<p>TO:</p> <p>MAIN OFFICE</p> <p>REGIONAL OFFICES</p> <p>SUPERSEDED BY EI 73-042</p> <p>EFFECTIVE 6/12/1973</p>	<div style="text-align: center;">  <h2 style="margin: 0;">ENGINEERING INSTRUCTION</h2> <p style="margin: 0;">NEW YORK STATE DEPARTMENT OF TRANSPORTATION</p> </div> <p>SUBJECT: BRIDGE ROOM 130</p> <p>Subject Code: 7.35-1-130</p>
<p>Distribution:</p> <p><input checked="" type="checkbox"/> Main Office <input checked="" type="checkbox"/> Regions <input type="checkbox"/> Special</p>	<p>Code: <u>EI 73-1</u></p>
<p>APPROVED:</p> <p style="text-align: center;"><i>R. M. Kemp</i></p> <p style="text-align: center;">Deputy Chief Engineer (Structures)</p>	<p>Date: <u>Jan. 2, 1973</u></p> <p>Supersedes: BR 130</p> <p>Dated Oct., 1971</p>

Effective immediately, revised Sheet BR 130 dated Jan., 1973 will supersede Sheet BR 130 dated Oct., 1971.

DETAILS FOR HANDRAIL

BR 130
Jan. 1973

DETAIL OF HANDRAIL SPLICE

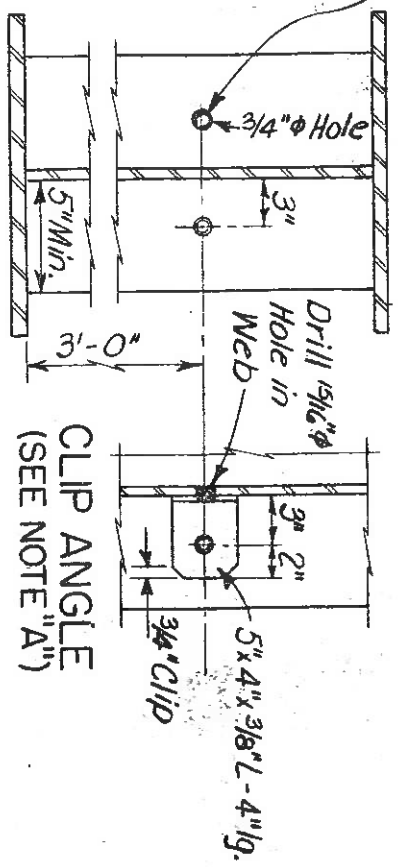
1. The Clip Angle Detail and the Detail at Cap Screw has been added.
2. The length of Handrail Splice has been changed from 4" to 8".
